SF736

Subject: Cascadia CTP3 Antennas

On behalf of the entity listed below, Daimler Truck North America LLC (DTNA), is initiating Field Service Campaign SF736 to modify the affected vehicles.

PROBLEM: On certain Freightliner Cascadia vehicles, the CTP3 antennas and associated coaxial cables may have been damaged during installation.

Fig 1, Top View of the Electronics Bay

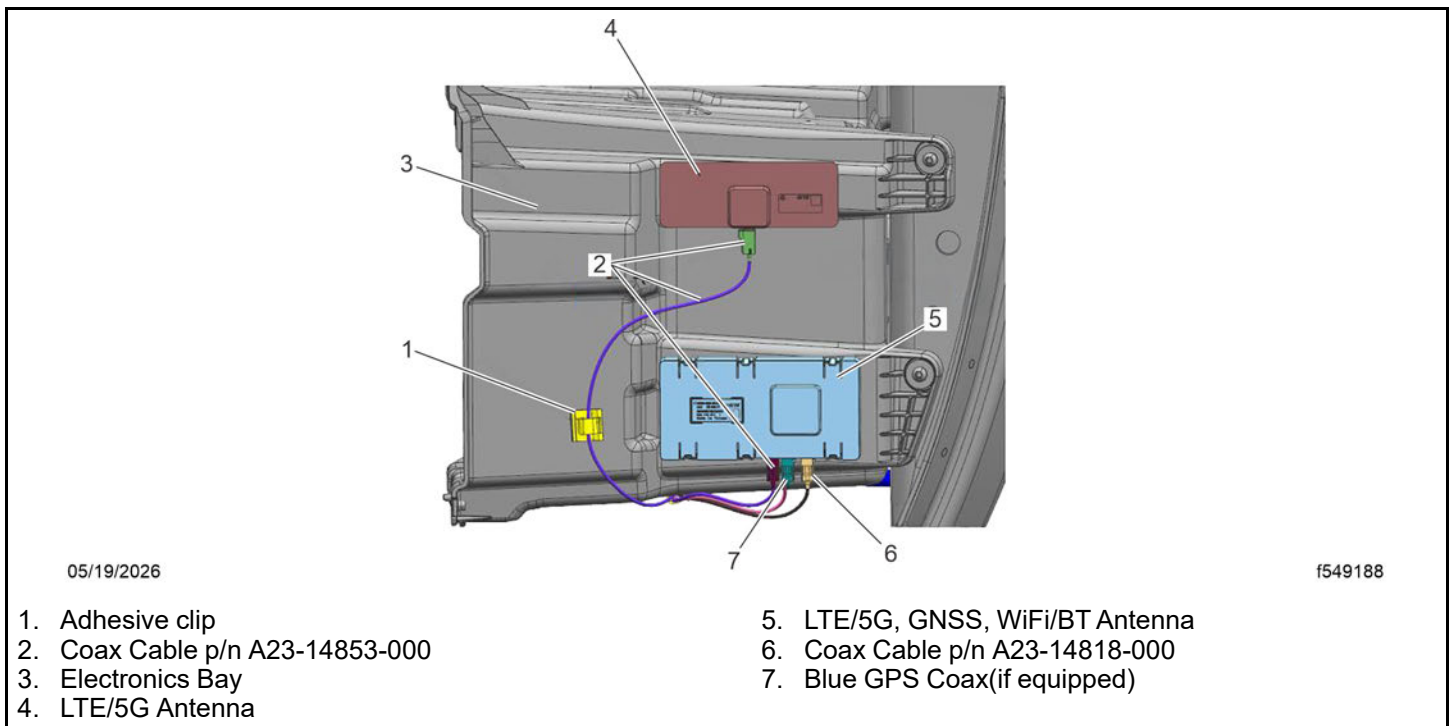
8. Connect both of the new coaxial cables (A23-14818-000 and A23-14853-000) from the topside antennas to the CTP ECU and the internal antennas. Connect all connectors to the antennas and the CTP ECU internal antennas, making sure to match them by color. Use installation drawing **D66-28199-000** as a reference for coaxial cable routing and clipping points. Secure all coaxial cables using adhesive clips and tie straps as indicated in the installation drawing. Replace any missing, misplaced, and/or broken clips as required. Some vehicles require an adhesive clip to be added to the top of the electronics bay and used according to installation drawing **D66-28199-000**. See [Fig. 1](#).
